Model 2461 High-Current SourceMeter® Instrument
2461-NFP
2461-RACK
2461-NFP-RACK

VERSION 1.7.12 RELEASE

VERSION 1.7.10 RELEASE

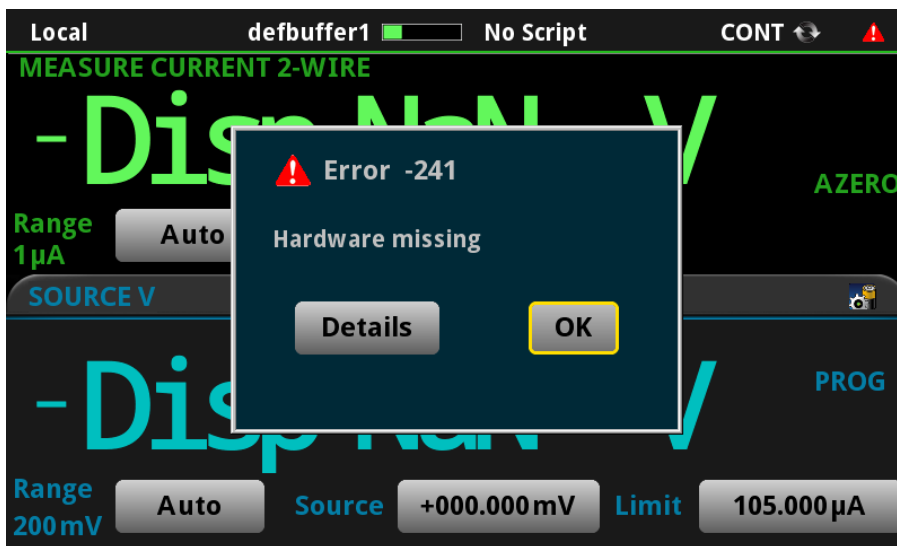
PR61502 From a cold power up, the Model 2461 SMU will sometimes fail with the following error message and will not operate properly.

If this issue occurs, a subsequent power cycle will allow the instrument to power up properly.

This issue has been corrected with firmware revision v.1.6.5.
